R.E. Ginna Nuclear Power Plant

**SUBJECT:** R.E. Ginna Nuclear Power Plant  
Docket No. 50-244

**Supplemental Information Related to Small Break (SB) Loss of Coolant  
Accident (LOCA) Analysis and Post-LOCA Boric Acid Precipitation  
Analysis**

**ENCLOSURE 1**  
**R.E. Ginna Nuclear Power Plant**  
**Additional SBLOCA Transient Results**

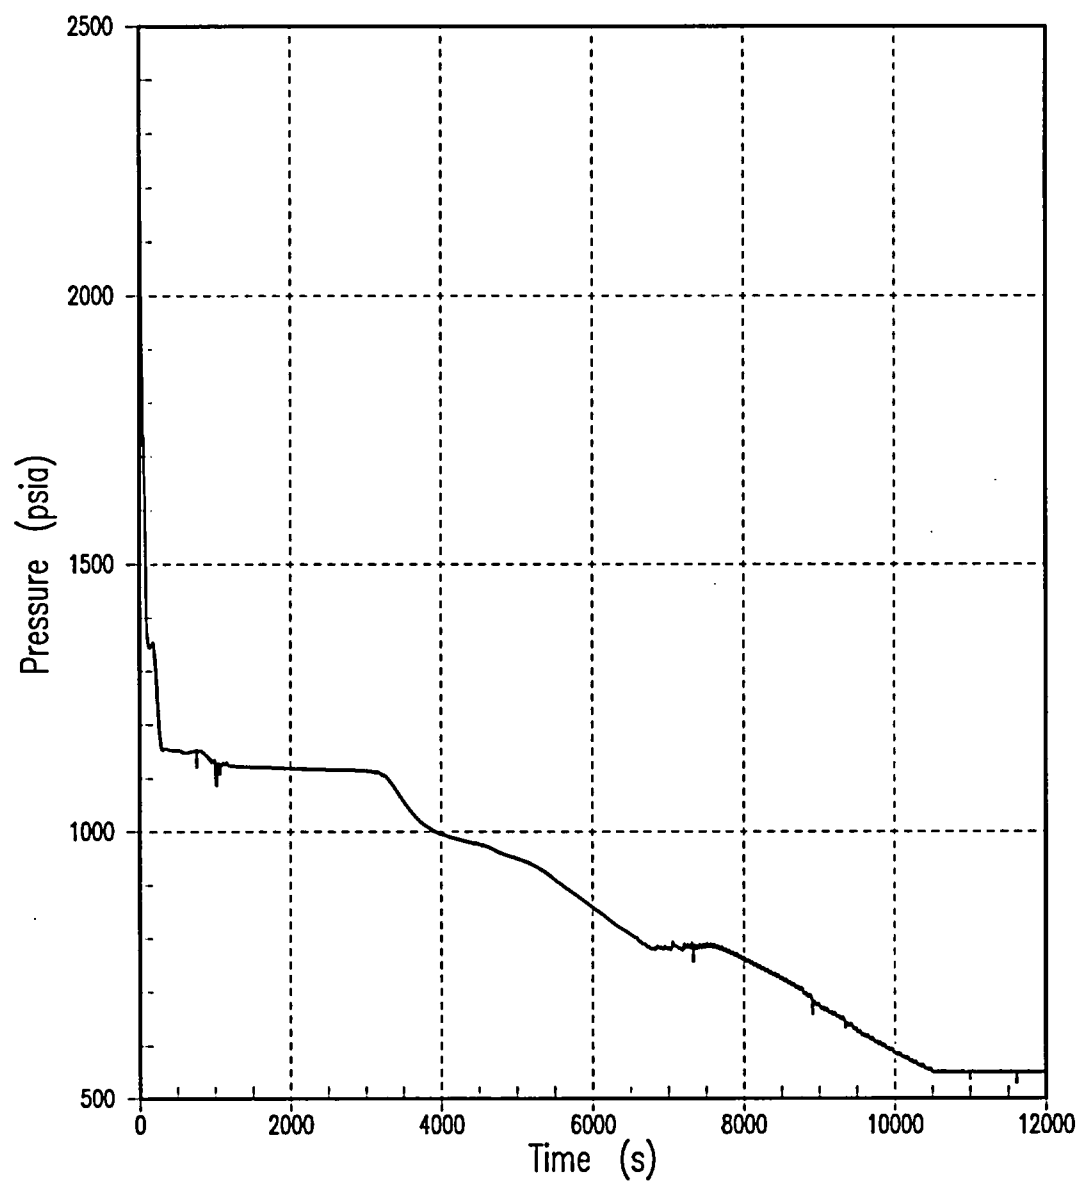
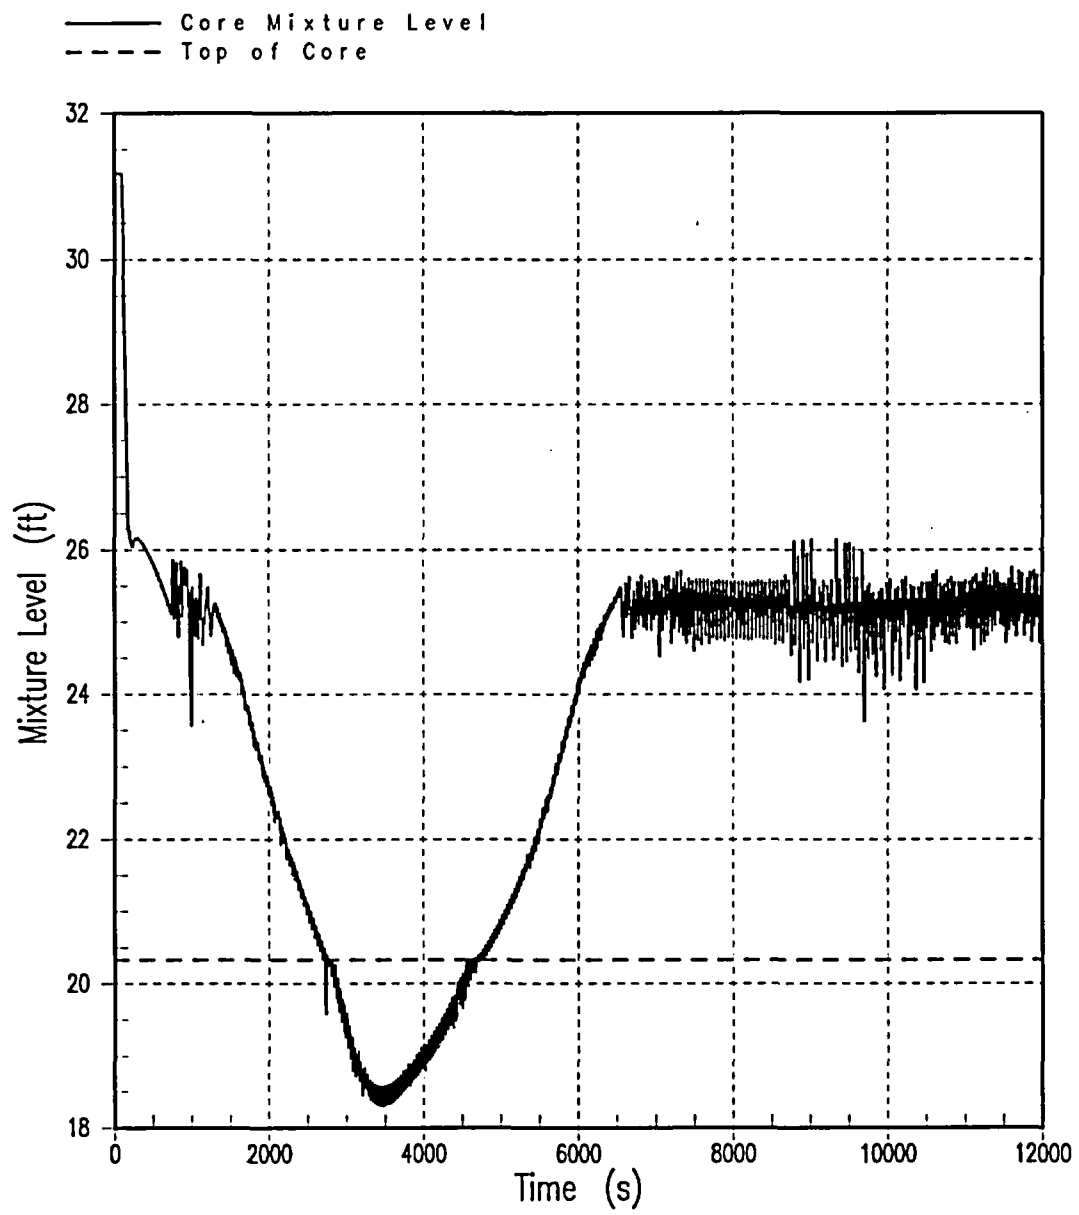
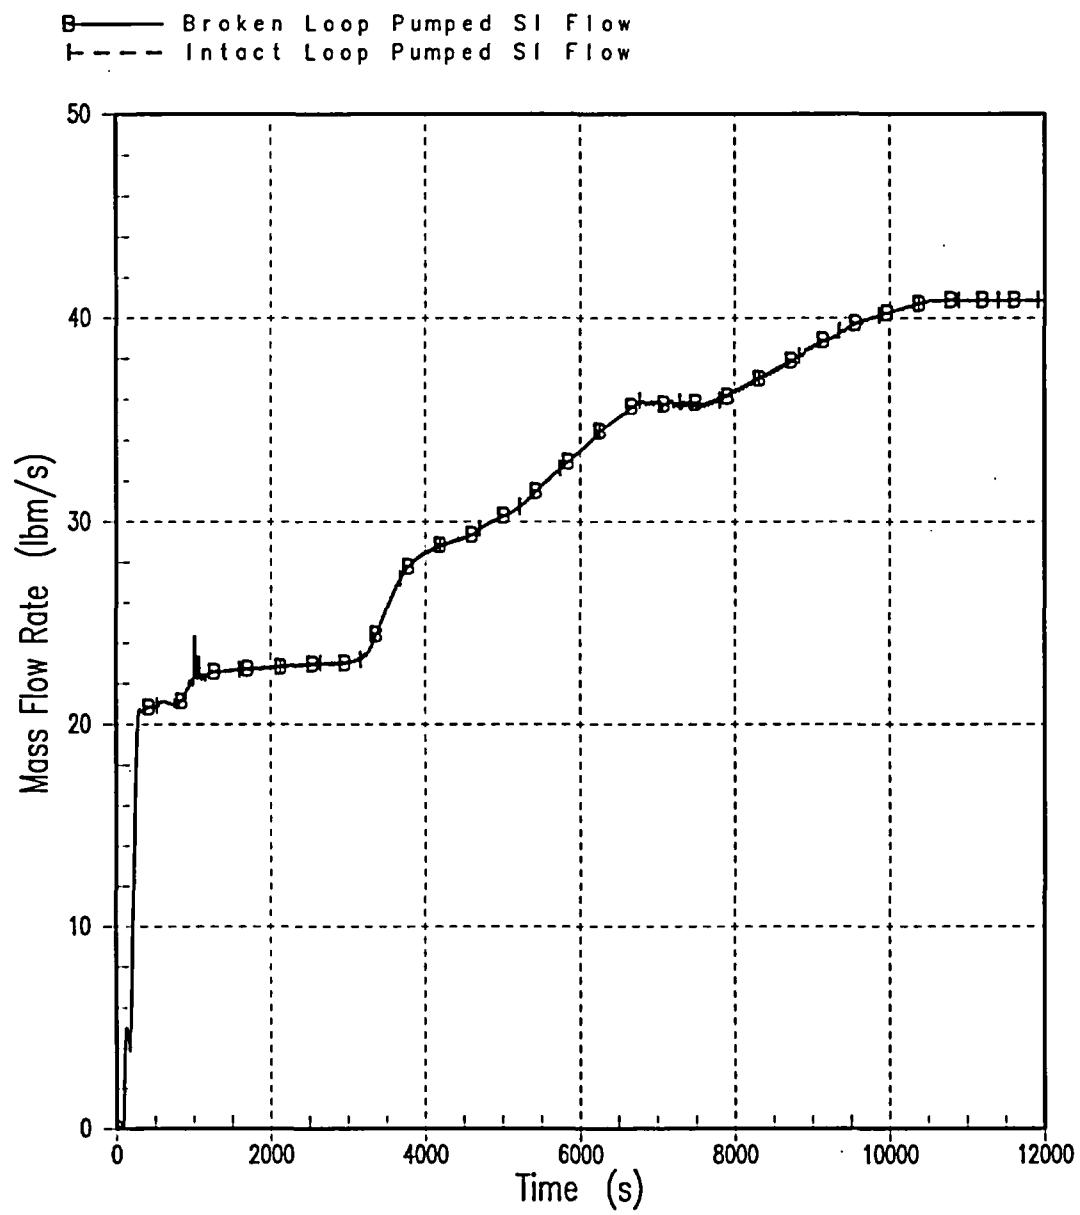
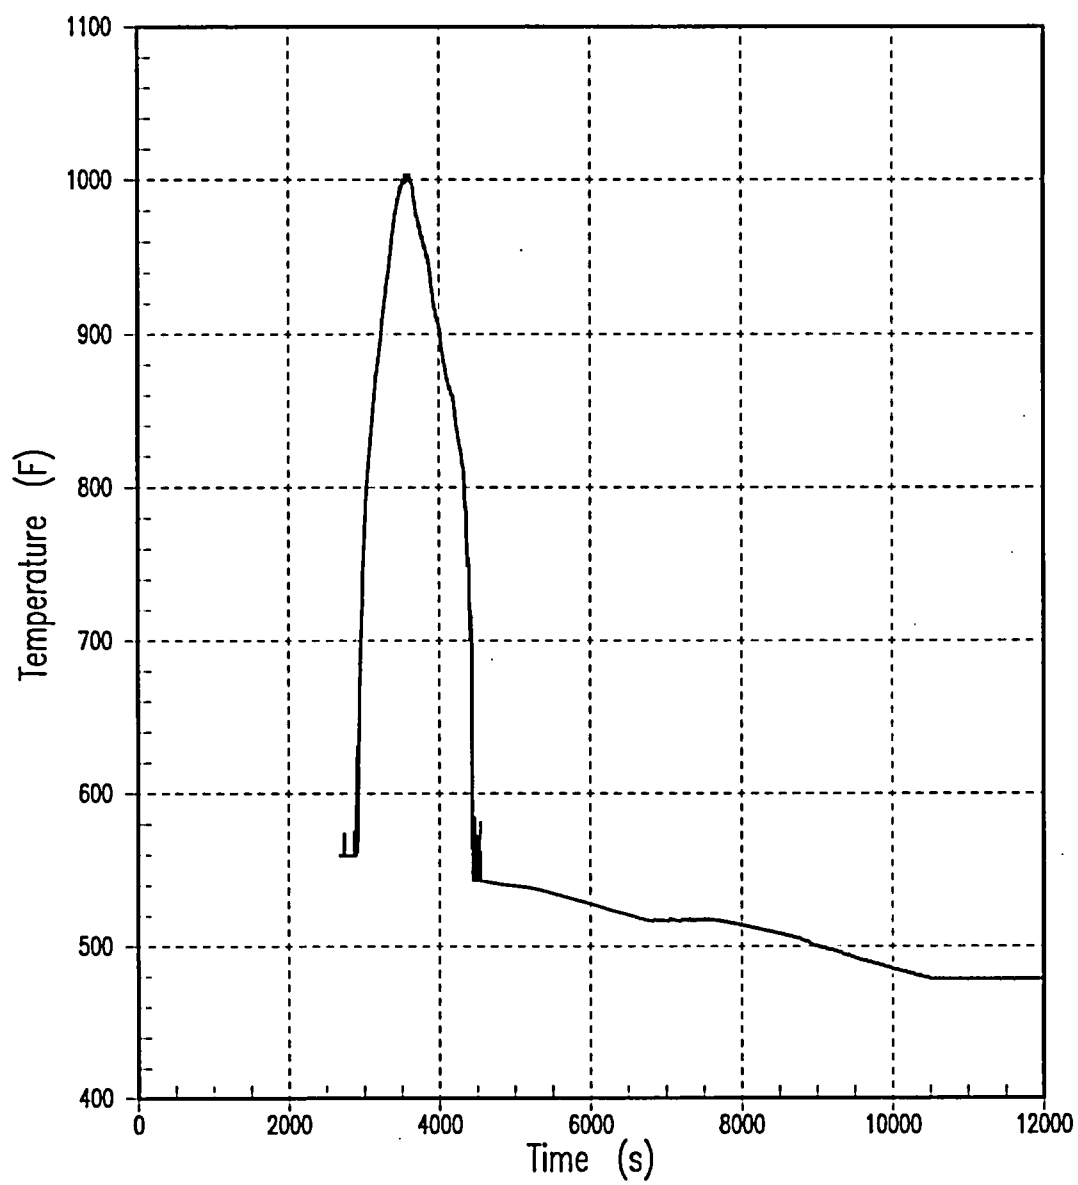
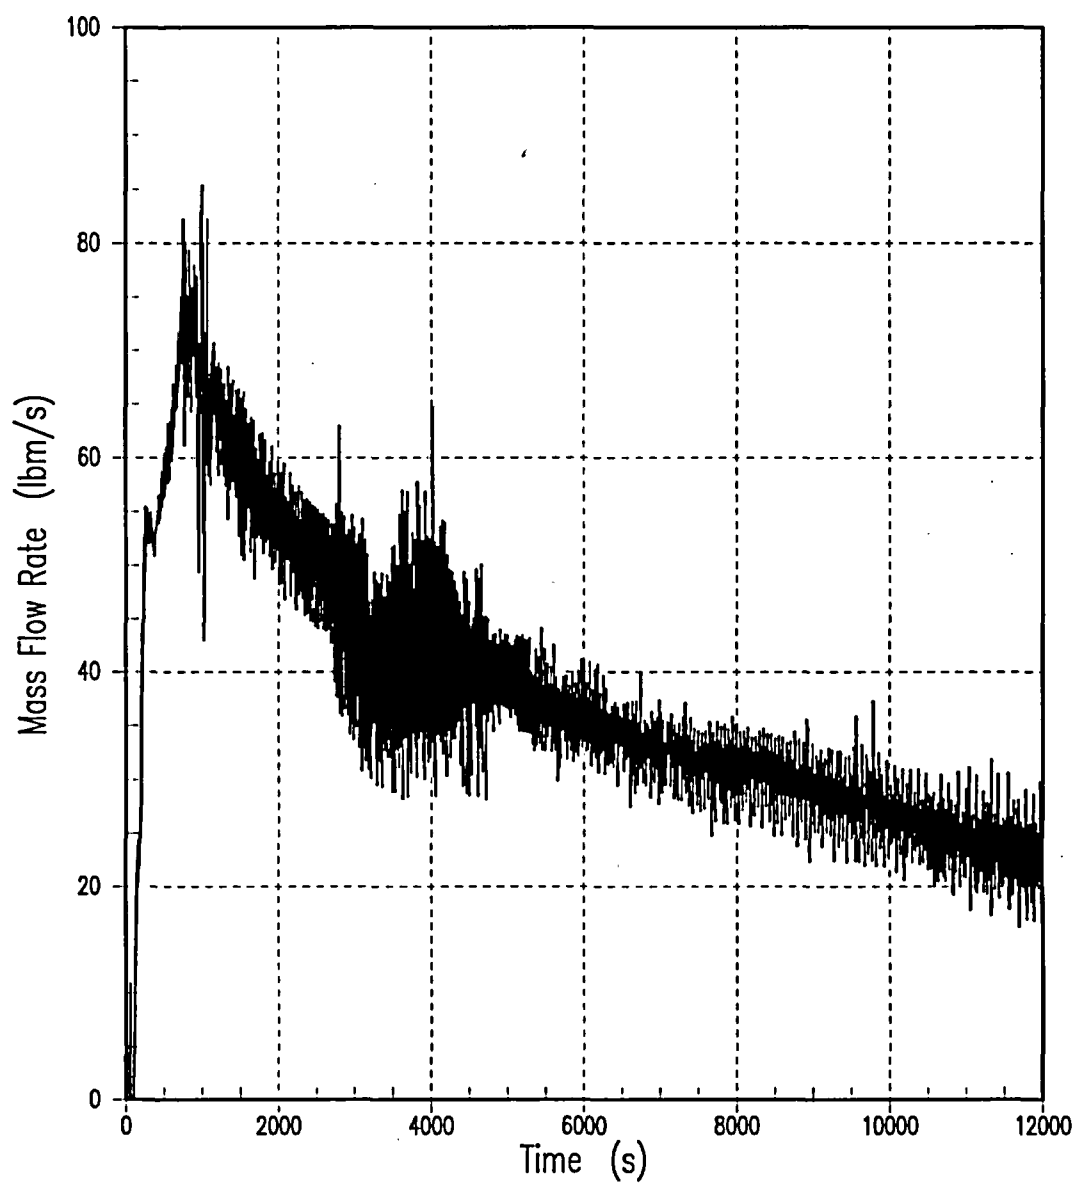
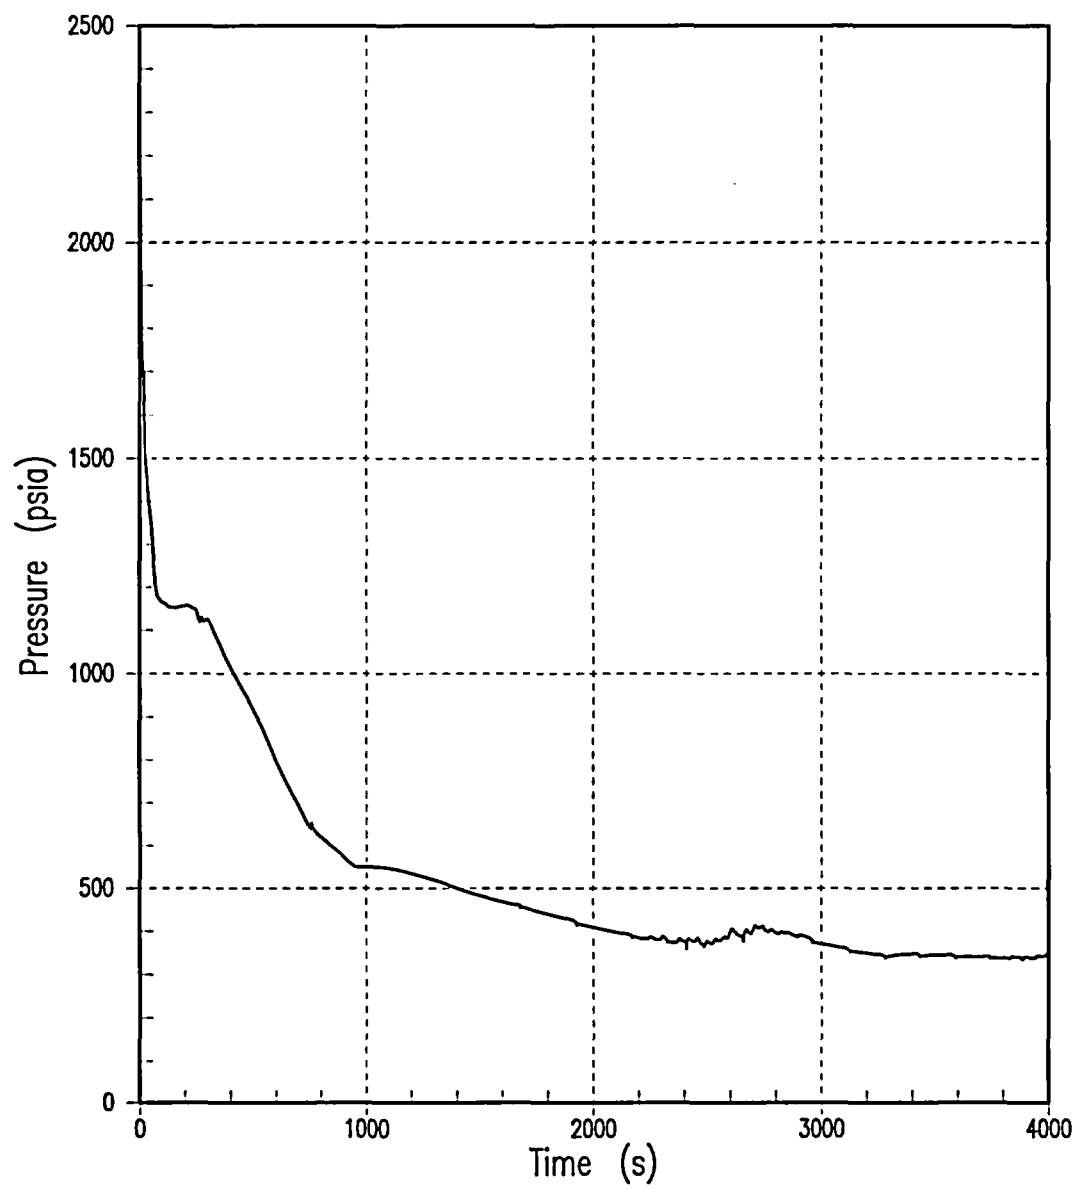
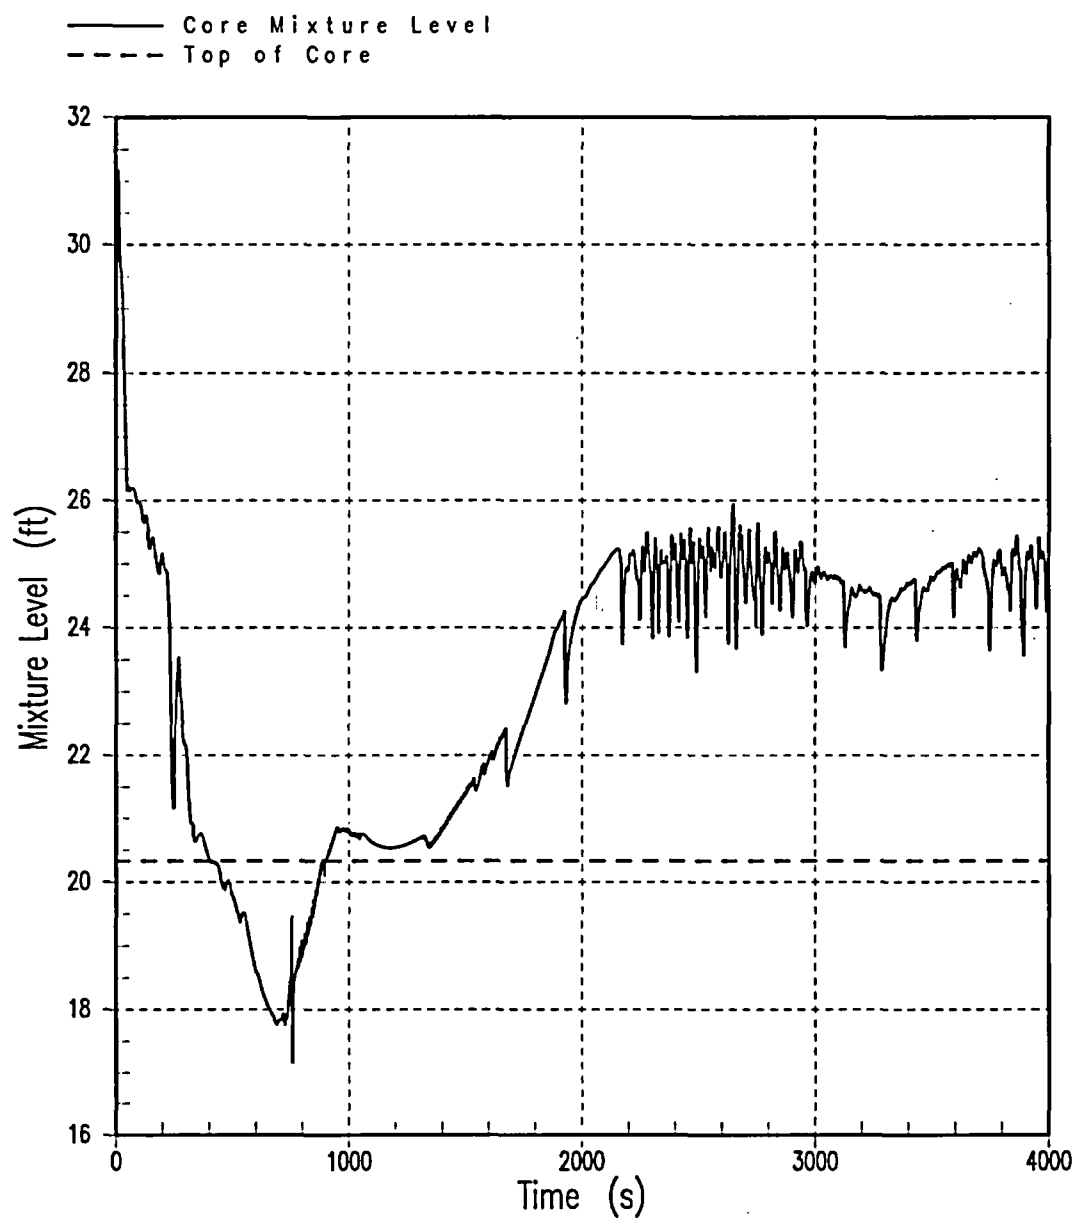
This letter responds to verbal requests for information received during a phone call with the NRC staff on August 11, 2005 related to the R.E. Ginna Nuclear Power Plant (Ginna) Extended Power Uprate (EPU). The requested information relates to the Small Break (SB) Loss of Coolant Accident (LOCA) analysis and the post-LOCA boric acid precipitation analysis. This additional information should clarify the evaluation methods used for the Ginna EPU in these areas to allow the NRC staff to proceed with its detailed technical review of the EPU.

The SBLOCA and post-LOCA boric acid precipitation analyses for the Ginna EPU were provided to NRC in Reference 1 [Pre-submittal to NRC dated 4/29/05]. Tables 4 and 5 of Enclosure 6 to Reference 1 provide a listing of SBLOCA transient and rod heat up results, respectively, for the 1.5", 2" and 3" breaks analyzed. SBLOCA transient parameter plots were only provided for the limiting 2" break in Reference 1. Enclosure 1 to this letter provides similar parameter plots for the 1.5" and 3" breaks analyzed and documented for the Ginna EPU. In addition, although not documented in the analysis, 4" and 6" break size transient calculations for the Ginna EPU were performed to demonstrate that no core uncover occurred for these breaks, thereby confirming that the range of breaks analyzed contained the limiting break. Additional SBLOCA transient behavior can be found in NRC-approved topical report, Reference 2 [WCAP-10054-P-A, Addendum 2, Revision 1].
